# Mountain Walk Townhomes

Cobb County, Georgia

# Z-10

**PETITION NO.:** Z-10

Preliminary Site Plan

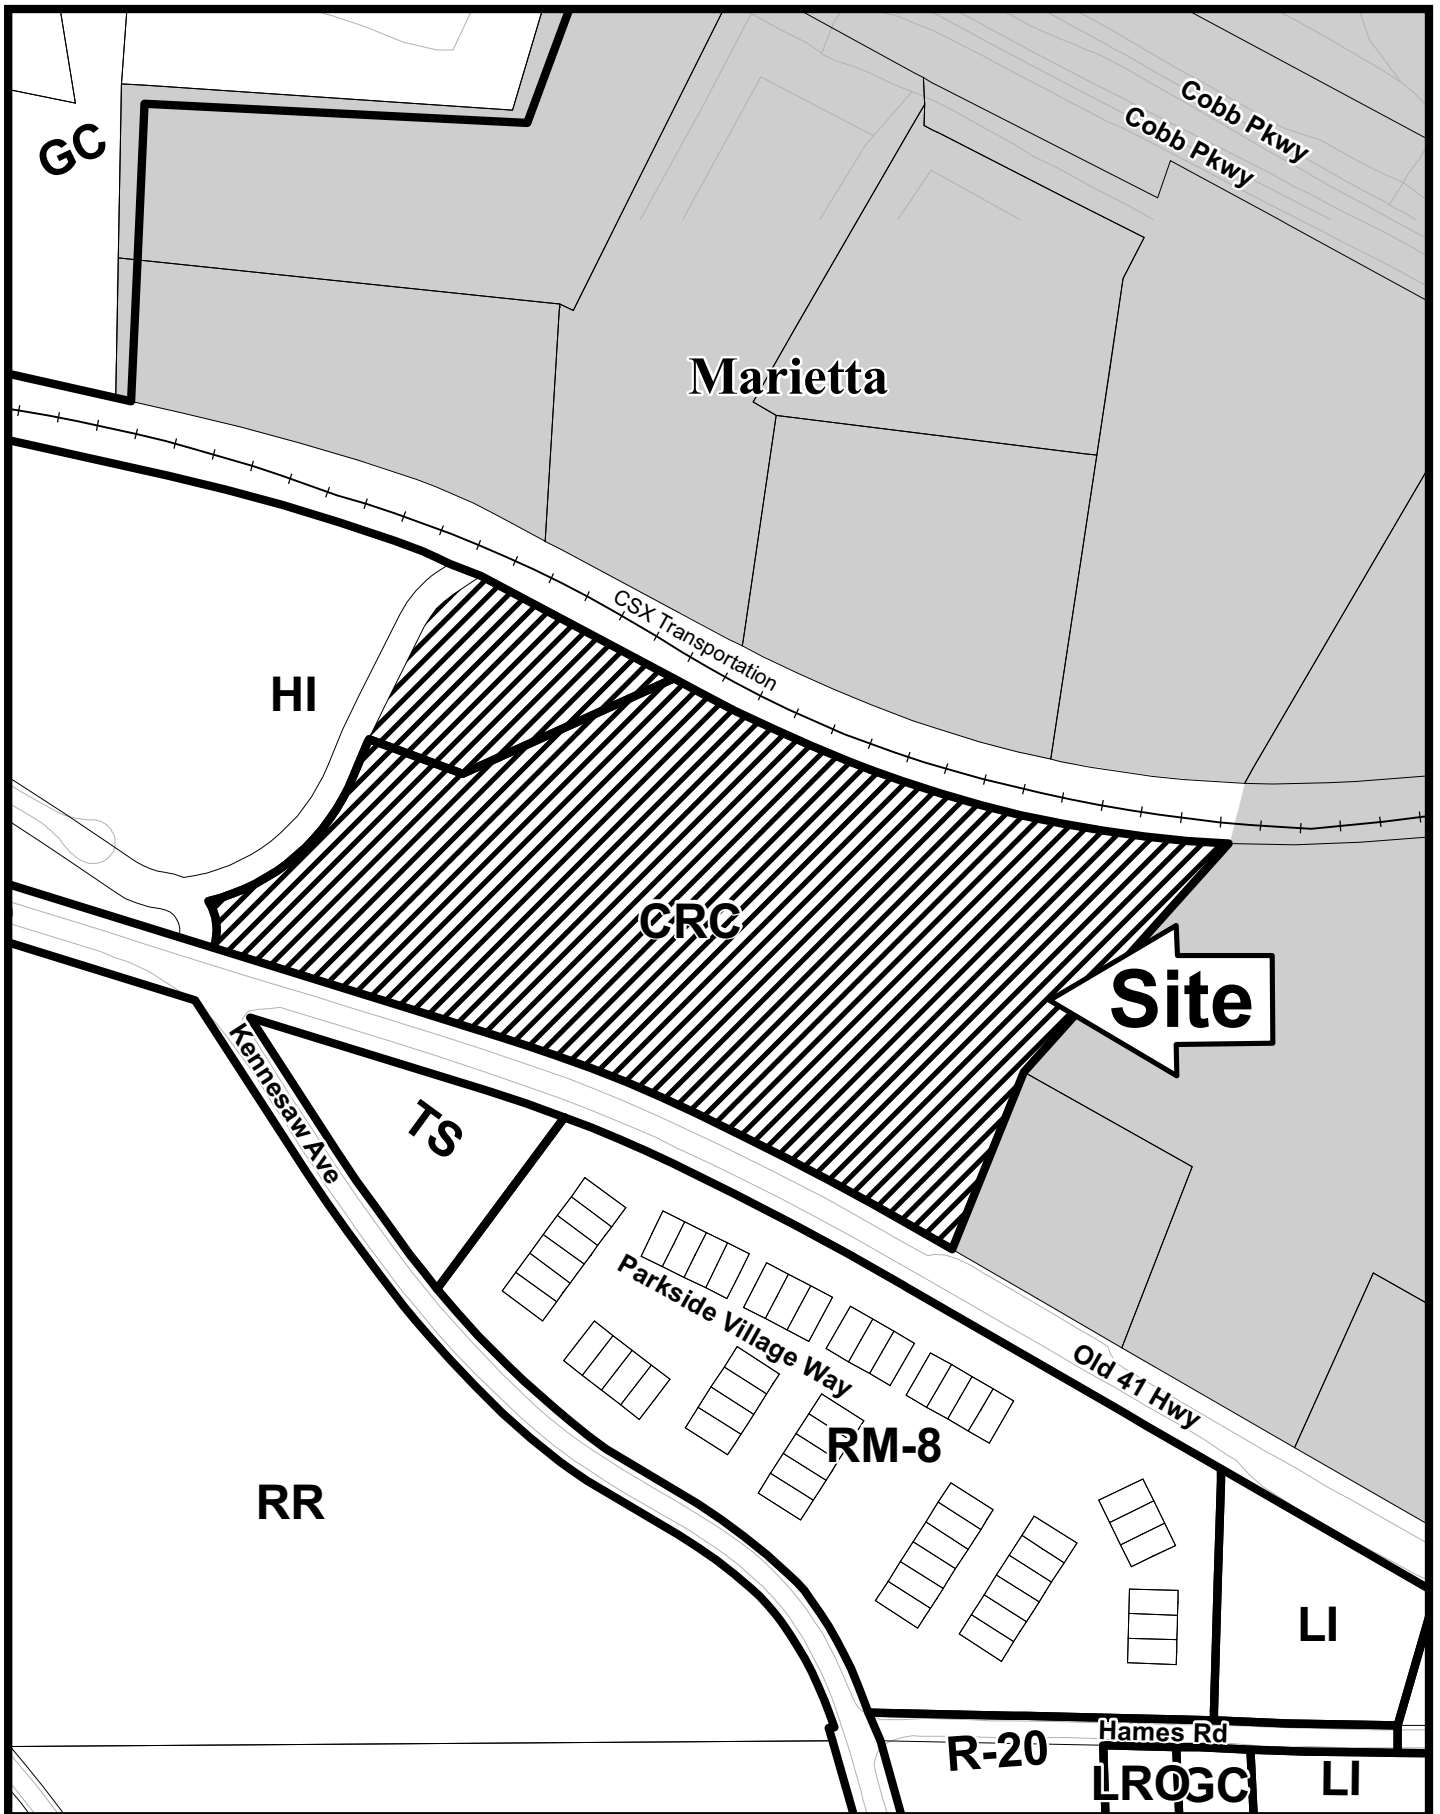
The submitted plan demonstrates a reduction in the rear setback from the required 30 feet to 25 feet adjacent to the CSX Railroad. Also, the applicant is presenting increased setbacks on the sides from 15 feet to 35 feet with 25 foot buffers.

- No Stormwater controls shown \_\_\_\_\_
- Copy of survey is not current – Additional comments may be forthcoming when current site conditions are exposed.
- No site improvements showing on exhibit.

1. A drainage easement agreement may need to negotiated with the adjacent property owner, Capital Materials, to provide a stable conveyance from the site to the existing culvert under the railroad.
2. Private roads are proposed which will require that all stormwater infrastructure be maintained by the HOA.
